TECHNICAL EVALUATION REPORT
SHEARON HARRIS NUCLEAR POWER PLANT,
UNIT NUMBER 1
STATION BLACKOUT EVALUATION

TAC No. ^M68552

Final
August 22, 1991

U.S. Nuclear Regulatory Commission
Washington, D.C. 20555

Figure 1: Shearon Harris Nuclear Power Plant Main One-Line Diagram

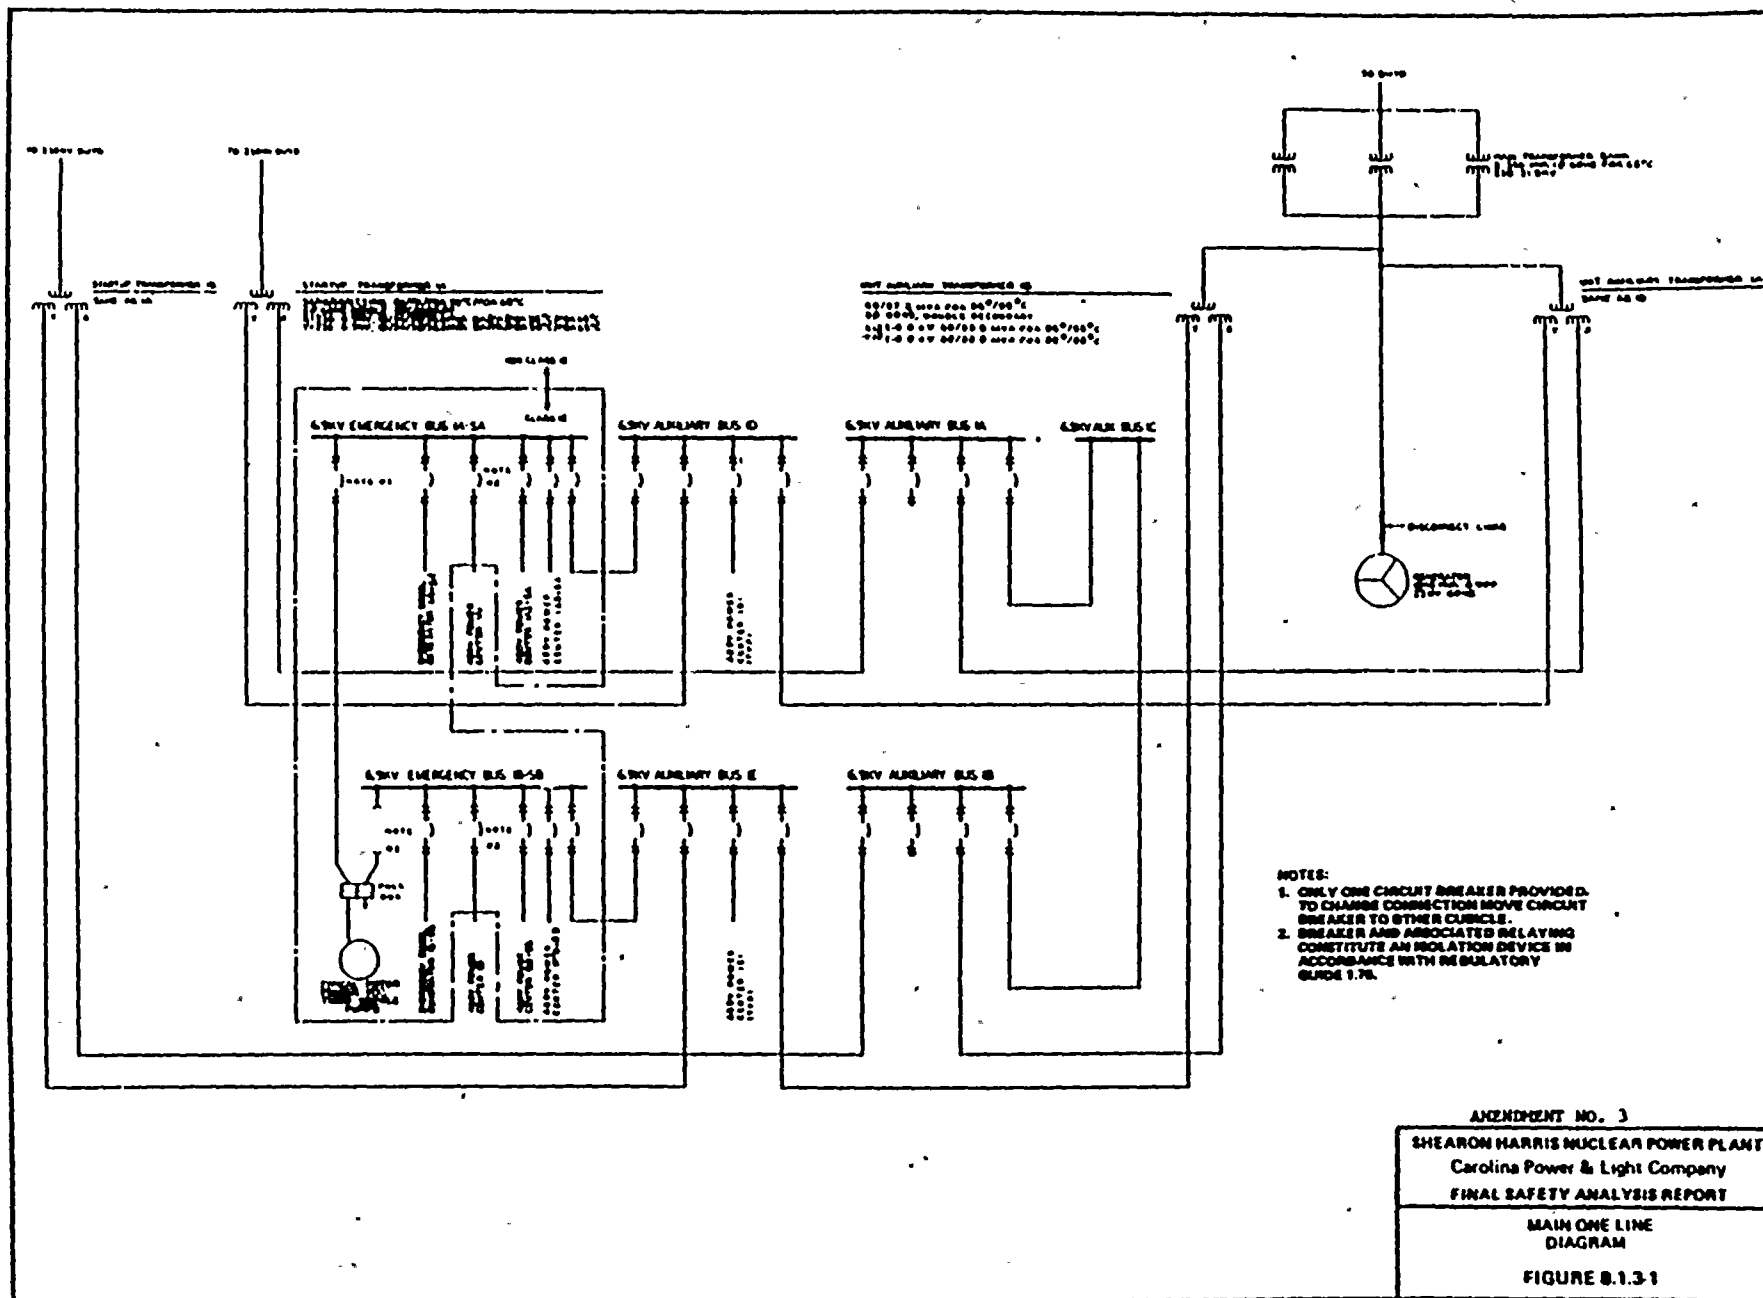
The licensee stated that the independence of the plant offsite power system grouping is "I1/2." A review of the Shearon Harris FSAR shows that, see Figure 1 (12):

1. All offsite sources are connected to the plant through a single 230 kV switchyard;
2. During normal operation, the essential buses (two emergency trains) are powered from the main generator through the unit auxiliary transformers;
3. Upon loss of power from the main generator, each emergency train is powered from an independent offsite power source through a start-up transformer;
4. Upon loss of power from one of the start-up transformers, there is no auto or manual transfer to an alternate power source.

Based on the above, the plant independence of offsite power system group is "I3." This determination is based on the guidance of Table 5 of RG 1.155 which states that if the normal source of offsite power is from the main generator, there needs to be an automatic and a manual/automatic

transfer of all safety buses to the preferred and alternate power sources. It appears that the licensee has assumed the capability to disconnect the main generator and backfeed power to the emergency buses from the grid as a viable transfer to an alternate offsite power source to support the independence of offsite power system group classification of "I1/2." The removal of a disconnect link typically takes several hours to complete and cannot be considered an acceptable means of transfer, according to the guidelines of NUMARC 87-00 Supplemental Questions/Answers (11).
